AGENDA
PLANNING AND ZONING COMMISSION WORK SESSION
City Hall, 385 South Goliad, Rockwall, Texas
Council Chambers
October 29, 2019
6:00 P.M.

9. **SP2019-037 (David)**
Discuss and consider a request by Anna C. Blackwell of Carrillo Engineering, LLC on behalf of Eddie Martin of Retail Partners, LLC for the approval of a site plan for a strip retail center on a 1.1755-acre parcel of land identified as Lot 26 of the Lake Ridge Estates Addition, City of Rockwall, Rockwall County, Texas, situated within the *Ridge Road Retail Subdistrict* of Planned Development District 32 (PD-32), located within the Scenic Overlay (SOV) District, addressed as 2930 Ridge Road [FM-740], and take any action necessary.

Discuss and consider a request by LeeAnn Latimer on behalf of Dr. Steve Arze of Zaph & Ath Properties, LLC for the approval of a site plan for a medical office building on a 1.36-acre tract of land identified as Lot 2, Block A, Landing Point Addition, City of Rockwall, Rockwall County, Texas, zoned Commercial (C) District, located north of the intersection of Industrial Boulevard and Airport Road, and take any action necessary.

SHEET NO.:
L1.01

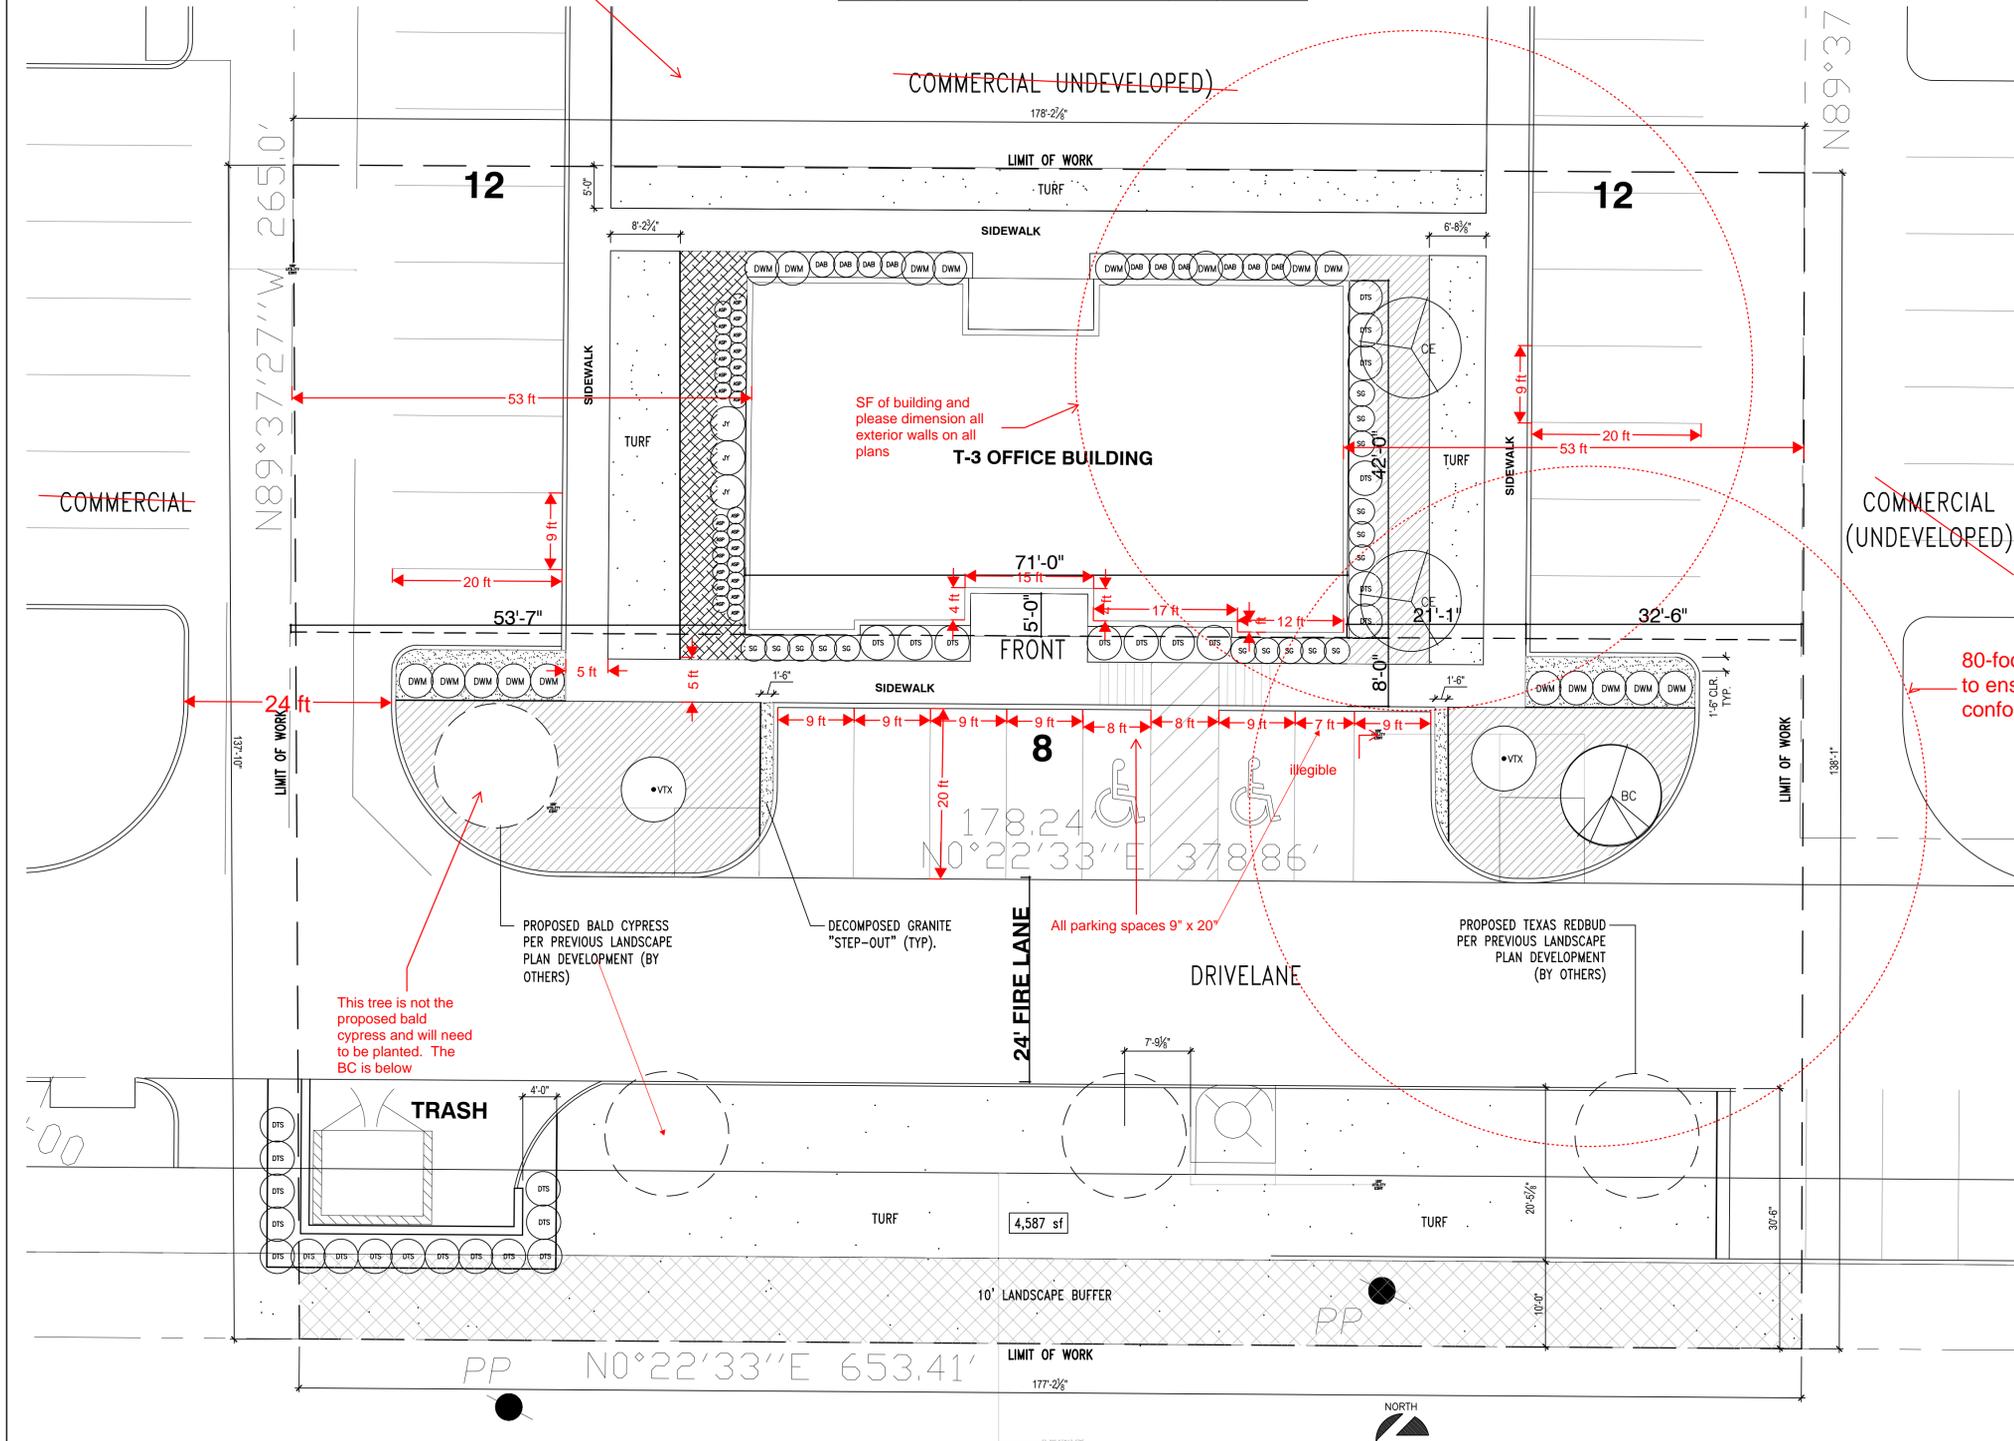
Please show all of Lot 2

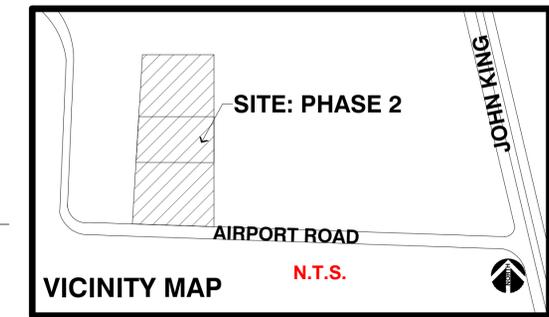
Please note that Lot 2 cannot be subdivided.

Please provide site data table and developer table as shown on the Landscape Plan
